# Access Compliance Report

## Public Rights-of-Way

Intersection ID: N/A	Main Street: SHOPTON_RD	Cross Street: DIXIE_RIVER_RD	Location: SW
ADA ID: 1B836D9F27BB	Ramp Type: Para	Initial Pass/Fail: Fail	Overall Compliance: No
Severity Score: 26.25			
Codes/Mitigation Info/Possible Solution		Field Measurements/Component Compliance

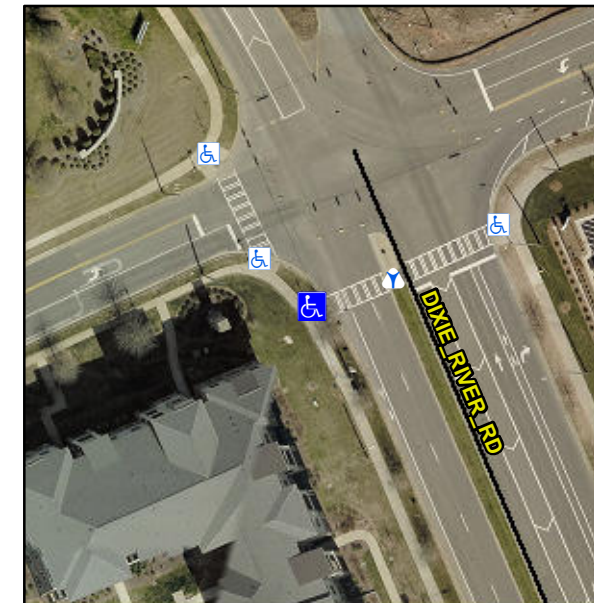
**RT RP < 5%**

**R304.3.2, R304.5.3**

Compliance	Description	Data	Compliance	Description	Data
N/A	Ramp Length LT (in)	66.0	N/A	Ramp Length RT (in)	64.0
Yes	Ramp Width LT (in)	95.0	Yes	Ramp Width RT (in)	96.0
No	Ramp Slope LT (%)	12.0	Yes	Ramp Slope RT (%)	2.9
No	Ramp XSlope LT (%)	2.3	No	Ramp XSlope RT (%)	3.8
N/A	Landing Length (in)	N/A	N/A	DWS Provided?	N/A
N/A	Landing Width (in)	N/A	N/A	DWS Contrast?	N/A
N/A	Landing Slope (%)	N/A	N/A	DWS Length (in)	N/A
N/A	Landing X Slope (%)	N/A	N/A	DWS Full Width?	N/A
N/A	Landing Curb? (Y/N)	N/A	N/A	DWS Offset (in)	N/A
N/A	Shared Landing?	N/A			
N/A	Gutter Ponding?	N/A	N/A	Gutter Slope (%)	N/A
N/A	Gutter Lip Ht (in)	N/A	N/A	Gutter X Slope (%)	N/A
N/A	Painted X Walk1?	Yes	N/A	Painted X Walk2?	N/A
	X Walk 1 Direction	To E		X Walk 2 Direction	N/A
N/A	X Walk 1 Width (in)	113.0	N/A	X Walk 2 Width (in)	N/A
	X Walk 1 Slope (%)	1.6		X Walk 2 Slope (%)	N/A
	X Walk 1 X Slope (%)	1.4		X Walk 2 X Slope (%)	N/A
N/A	Ramp inside XWalk1?	Yes	N/A	Ramp inside XWalk2?	N/A

**Remove & Replace Entire Ramp.**
